Contract #: 04-0120F4Cty: SF/ALA Rte: 80 PM: 13.2/13.9File #: 69.25B**QUALITY ASSURANCE -- NON-CONFORMANCE REPORT****Location:** Changxing Island, Shanghai, P.R. China**Report No:** NCR-000938**Prime Contractor:** American Bridge/Fluor Enterprises, a JV**Date:** 12-Dec-2010**Submitting Contractor:** Zhenhua Port Machinery Company, Ltd (ZPMC), Changxing Island**NCR #:** ZPMC-0899**Type of problem:**

Reference Description: ZPMC performed welding without an approved WPS and following its min. preheat temperature requirement in Segment 12AE/12BE Bottom Splice

Subject: NCR No. ZPMC-0899

Contract #: 04-0120F4Cty: SF/ALA Rte: 80 PM: 13.2/13.9File #: xx.25A**QUALITY ASSURANCE -- NON-CONFORMANCE RESOLUTION****Location:** Changxing Island, Shanghai, P.R. China**Report No:** NCS-000927**Prime Contractor:** American Bridge/Fluor Enterprises, a JV**Date:** 27-Jan-2011**Submitting Contractor:** Zhenhua Port Machinery Company, Ltd (ZPMC), Changxing Island **NCR #:** ZPMC-0899**Type of problem:**

Location: Segment 12AE/12BE

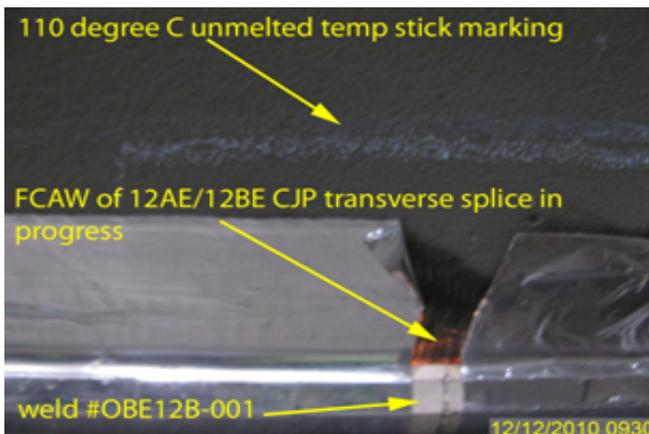
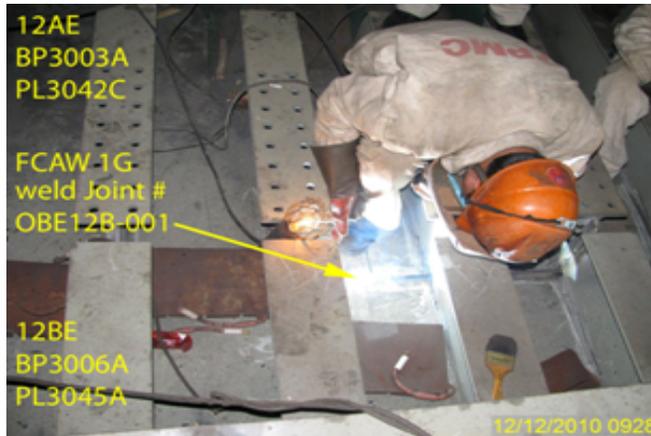
- Welding was performed using a Welding Procedure Specification (WPS-B-T-2231T-ESAB) that has not been approved.
- The WPS specifies a minimum preheat value of 110 degrees Celsius for material up to 40mm in thickness, however, the minimum preheat temperature was not met within 75mm adjacent from the point of welding.

- Bottom Plate transverse Complete Joint Penetration (CJP) splice (Weld ID# OBE12B-001).
- Bottom Plates splice is identified as BP3003A (PL3042C) in 12AE; BP3006A (PL3045A) in 12BE.
- The material of the Bottom Plates is 30mm in thickness.
- Members are Non-Seismic Performance Critical Members (non-SPCM).
- Welding was being performed using the Flux Cored Arc Welding (FCAW) process in the 1G (flat) position.

AWS D1.5 (2002), Sections: 4.2 Preheat and Interpass Temperature Requirements, 4.2.7 When the base metal is below the temperature listed for the welding process being used and the thickness of material being welded, it shall be preheated (except as otherwise provided) in such a manner that the steel on which weld metal is being deposited is at or above the specified minimum temperature for a distance equal to the thickness of the part being welded, but not less than 75 mm [3 in.] in all directions from the point of welding.

The WPS has since been approved by the Department and ZPMC is providing the NDT of the weld to show that it is acceptable. The QC responsible for this incident has been reminded to ensure the welders are welding in accordance with the WPS. To prevent future incidents of welding with unapproved WPS, ZPMC will submit WPS earlier for approval before they are required. Based on this ZPMC request closure of this NCR.

This proposed resolution is acceptable. The documentation received is sufficient and the Department concurs that Non-Conformance ZPMC-0899 is closed.

Location: Segment 12AE/12BE

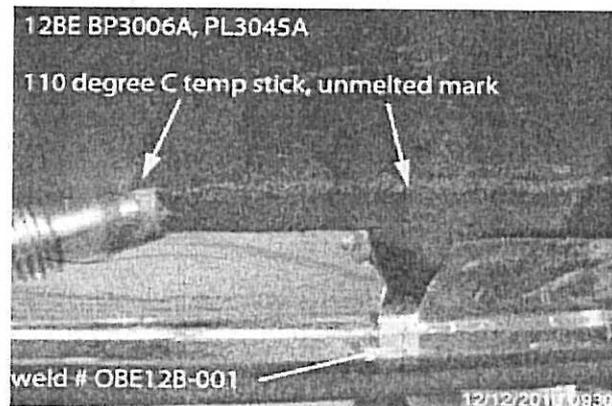
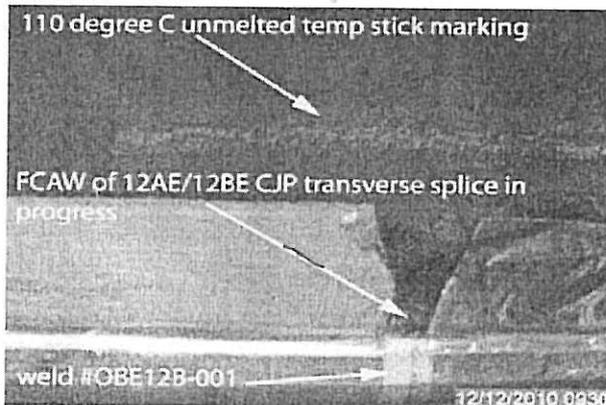
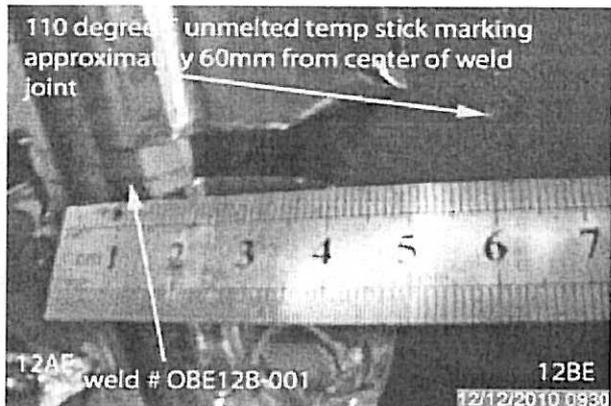
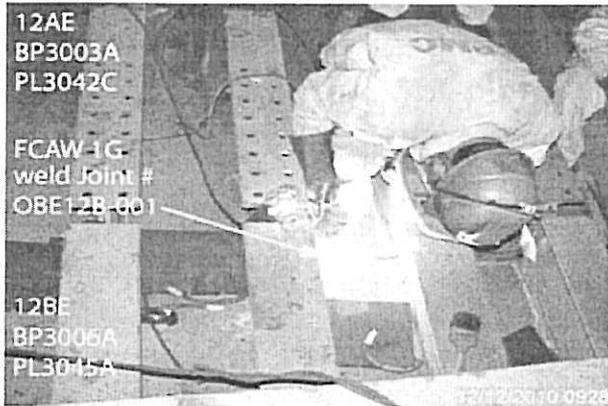
- Welding was performed using a Welding Procedure Specification (WPS-B-T-2231T-ESAB) that has not been approved.
- The WPS specifies a minimum preheat value of 110 degrees Celsius for material up to 40mm in thickness, however, the minimum preheat temperature was not met within 75mm adjacent from the point of welding.

- Bottom Plate transverse Complete Joint Penetration (CJP) splice (Weld ID# OBE12B-001).
- Bottom Plates splice is identified as BP3003A (PL3042C) in 12AE; BP3006A (PL3045A) in 12BE.
- The material of the Bottom Plates is 30mm in thickness.
- Members are Non-Seismic Performance Critical Members (non-SPCM).
- Welding was being performed using the Flux Cored Arc Welding (FCAW) process in the 1G (flat) position.

AWS D1.5 (2002), Sections: 4.2 Preheat and Interpass Temperature Requirements, 4.2.7 When the base metal is below the temperature listed for the welding process being used and the thickness of material being welded, it shall be preheated (except as otherwise provided) in such a manner that the steel on which weld metal is being deposited is at or above the specified minimum temperature for a distance equal to the thickness of the part being welded, but not less than 75 mm [3 in.] in all directions from the point of welding.

The unsatisfied welds have been removed and welded according WPS. ZPMC QC enhanced the welding and temperature control during welding. After welding, all the NDT inspections have been acceptable. ZPMC is providing the NDT reports to show the result. The non-conformance in NCR has been cleared. Please consider to close this NCR.

Contractor proposes to remove the welds, and re-weld according to an approved WPS. Contractor will perform the NDT, and provide the NDT report to prove the welds are acceptable. To avoid recurrence, WPS will be submitted for Engineer's approval earlier.

Contractor removed the welds, and re-welded according to the WPS which has subsequently been approved. The NDT report submitted showed that the welds are acceptable.
